Reference:	19/00783/FUL
Application Received:	Tue 19 Feb 2019
Application Validated:	Tue 19 Feb 2019
Address:	32 Woodmere Avenue Croydon CR0 7PB
Proposal:	Demolition of the existing property and the erection of a replacement detached two storey building with accommodation in the roof-space, comprising 7 self-contained flats (2 x 1 bedroom, 3 x 2 bedroom and 2 x 3 bedroom) with 5 off street car parking spaces, bike store, integrated refuse store and site access.
Status:	Awaiting decision
Case Officer:	Robert Lester
Consultation Close:	Thu 30 May 2019 (Extended)
Deadline determination:	Tue 16 Apr 2019

Resultant on the provision and notification of amended drawings, we have revised and updated our objection letter to take account of these changes to this development proposal. It is noted that the footprint of the proposal remains exactly the same and only the internal configuration has been modified to meet **London Plan Policy 3.5 – Minimum Space Standards** and the **Refuse** and **Bike Store** have been repositioned. Therefore, the main issues of **excessive and inappropriate Residential and Housing Densities** remain a significant non-compliance and reason for objection and **ref

Illustrations of the 45° Rule regarding adjacent properties

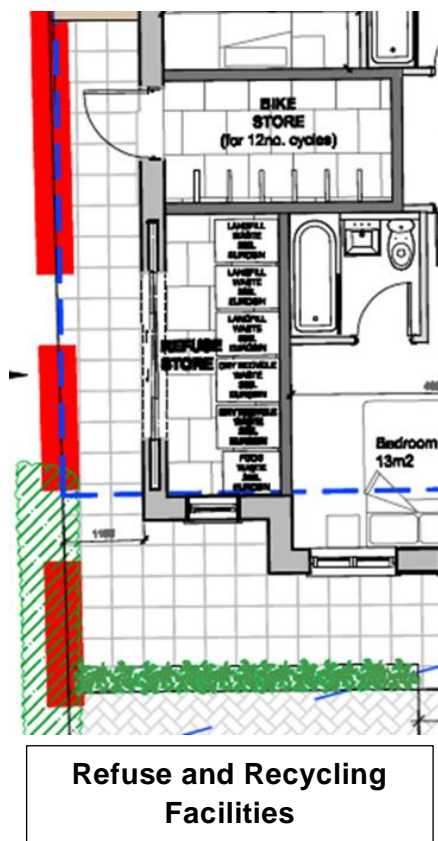
Although the offered drawings do not provide a rear elevation of the adjacent property at **30 Woodmere Avenue, Drawing PP02-02** illustrates the **45°** from middle of the window of the adjacent dwelling which can be estimated transposed to the front of the property to be about the centre of the street door as shown above; as **30 Woodmere Avenue** is tapered, the actual distance would be closer to the proposed development at the rear of the adjacent property and thus even worse than depicted on the diagram shown above. This illustrates that the proposed development **fails to meet the 45° rule on height** in relation to the **adjacent property at 30 Woodmere Avenue**. The Case Officer should request the applicant to provide rear elevations with the **45°** projection from the **centre of the ground floor window of the adjacent property** to verify compliance or otherwise with the **45° Rule**. The illustration above shows a significant overbearing nature of the proposed development on the adjacent property at **30 Woodmere Avenue** if measured from the **centre rear adjacent ground floor window**.

We object to the proposed development on grounds that it does **NOT meet the 45° Rule** on **height** as measured from the adjacent dwelling ground floor window as required by the emerging **Supplementary Planning Document SPD2, Chapter 2 Suburban Residential Developments at Para 2.11 Heights & Depths Projecting beyond Building Lines** at pages **36 & 37**, which results in overbearing and crowding to the adjacent dwelling.
